Minor Change to Development Approval at 9 Burdett Street Albion (Council Ref: A006603736)

In accordance with Section 78 of the *Planning Act 2016* (**'the Act'**) and on behalf of *Euroa Investments Pty Ltd* (**'the Applicant'**), please accept this minor change application in relation to the current development approval (A006603736) for a Material Change of Use (**'the approval'**) at 9 Burdett Street, Albion which is formally described as Lot 3 on RP72743.

Figure 2 - Revised basement layout

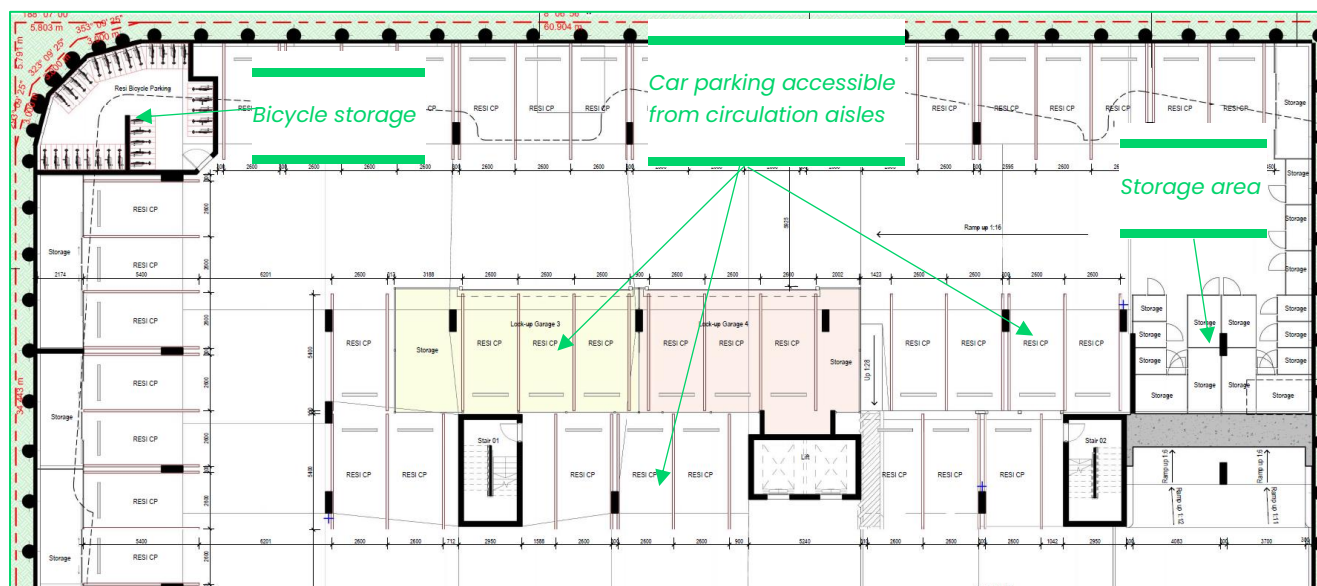
The parking area within the ground and two basement levels have been replanned to achieve improved efficiency in the layout. These changes have primarily been achieved through maximising the amount of parking which is accessible off the circulation aisles, with storage and bicycle storage areas being relocated to areas which require cannot accommodate car parking spaces. These changes are the key change which has resulted in the ability to remove the third basement level, which significantly reduces both construction costs and timeframes. Figure 2 provides an illustration of how the improved efficiency has been achieved.

Figure 3 - Proposed new access from Burdett Street

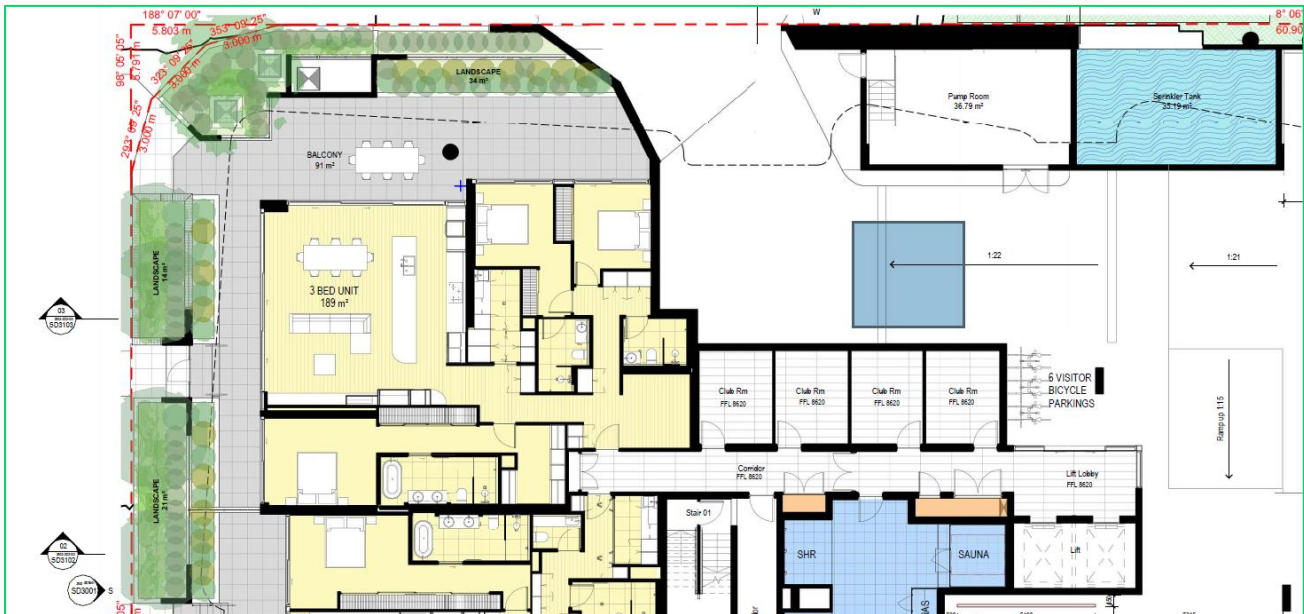
It is now proposed that two access points are proposed, a new access from Burdett Street for cars at the ground level, approximately one-third of the way along the Burdett Street from the Crosby Road intersection, and the retention of the existing access which is now predominantly for services and refuse vehicles (it is acknowledged that 3 car parking spaces will be accessed which are associated with the immediately adjacent 4-bedroom apartment). **Figure 3** below illustrates the new access point from Burdett Street. The suitability of the proposed access arrangement has been reviewed by Modus in the Traffic Engineering Letter, which is contained within **Appendix G**, despite some minor non-compliances with the TAPS PSP. It is noted that the Traffic Engineering letter has been signed by an RPEQ.

This change also results in the removal of the 3-bedroom unit on the Burdett Street frontage in order to accommodate the new access point. However, the existing access point has been reduced in width which has allowed for an additional apartment at level 1 (i.e. the ground level at the northern end of Burdett Street) and therefore there is no nett loss of activation to Burdett Street.

Figure 4 - Revised rooftop layout

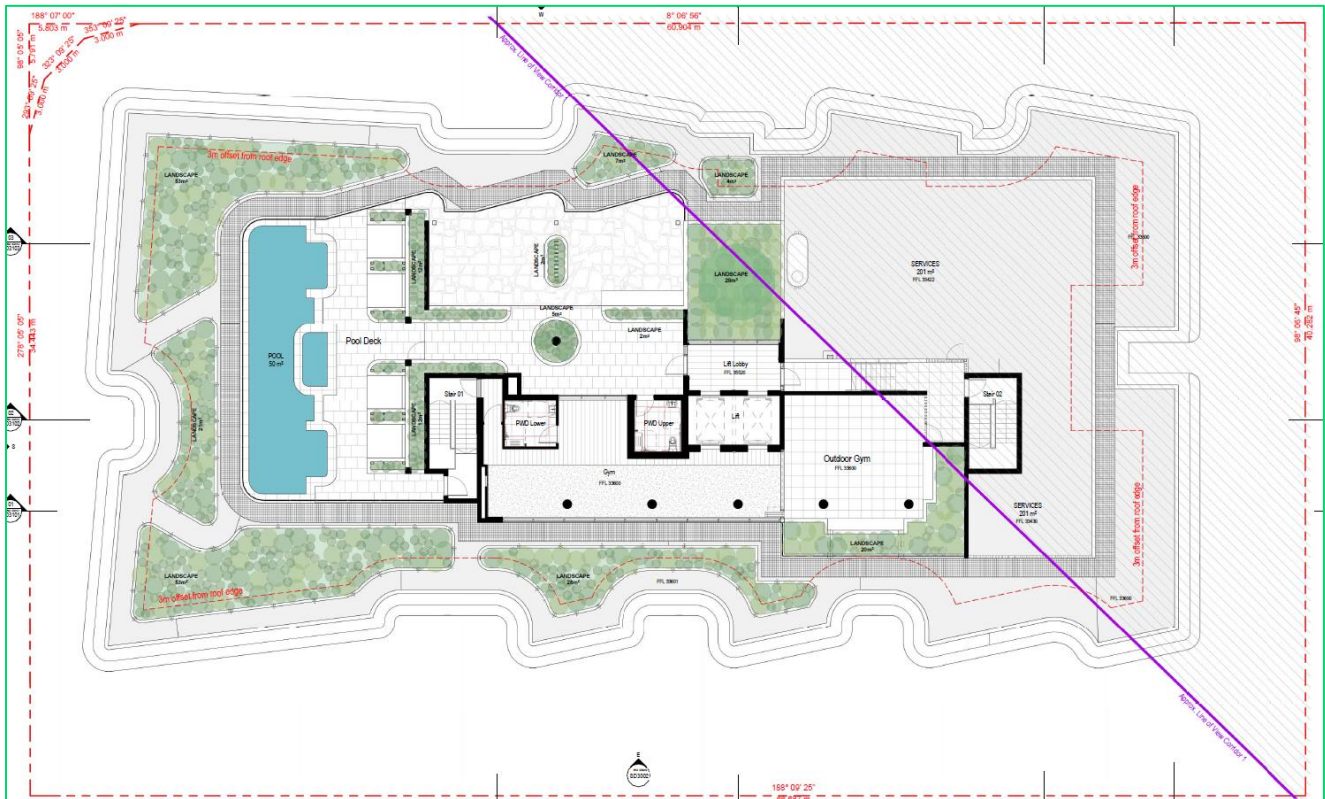
The proposed rooftop level has undergone a redesign which has resulted in a number of changes to the layout of this level, along with the communal facilities and building services which are located on the rooftop. These changes are outlined as follows:

- Enhancement of the communal recreation facilities through:
 - Reconfiguration of the pool and the addition of a space,
 - An increase to the landscaped area on the rooftop, particularly to the edges; and
 - The addition of an indoor and outdoor gym.
- An increase in the size of the building services area on the rooftop, which allows for the removal of the building services on level 2, as described below.

It is noted that the proposed changes to the rooftop result in some minor non-compliance with the definition of Rooftop Garden in the City Plan, and therefore the rooftop is now defined as a storey. It is also noted that the above changes do result in an increase in the amount of roofed area which sits above 33m AHD. Consideration of these changes against the relevant assessment benchmarks is outlined in Section 4.1 of this application.

Figure 30 – Outlook from the viewpoint for view corridor VC1 (Urbis)

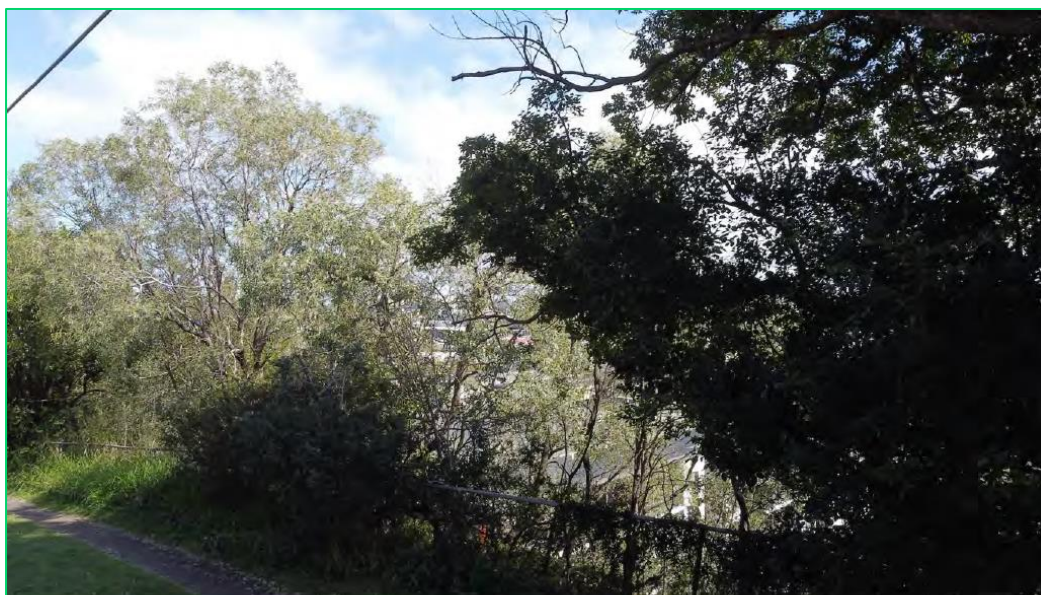
As part of the assessment of the previous 'other change' application, a Visual Impact Assessment of the changes were undertaken by Interplan, including analysis of the impact from the view corridor. Figure 30 from the Visual Impact Assessment, which is reproduced below, illustrates that at the point identified for the view corridor, the view is substantially blocked by existing mature vegetation in the verge and on the adjoining land. As a result of this Interplan concluded the following with respect to the View Corridor VC1 identified in the Albion Neighbourhood Plan (refer to paragraph 155).

Notably the VC1 view corridor is mostly obstructed by the existing vegetation at the rear of the property at 43 Burdett that adjoins Lapraik Street (refer to Figures 29 and 30 below). This property is within the MDR zone and should it be redeveloped for residential use up to 33m or 6 storeys in height, subject to the built form it would partially obstruct VC1 and views of the Changed Development.

This previous analysis demonstrates that the very minor changes to the extent of the rooftop which exceeds 33m AHD will continue to satisfy the requirement of PO2 to maintain the public view corridors.
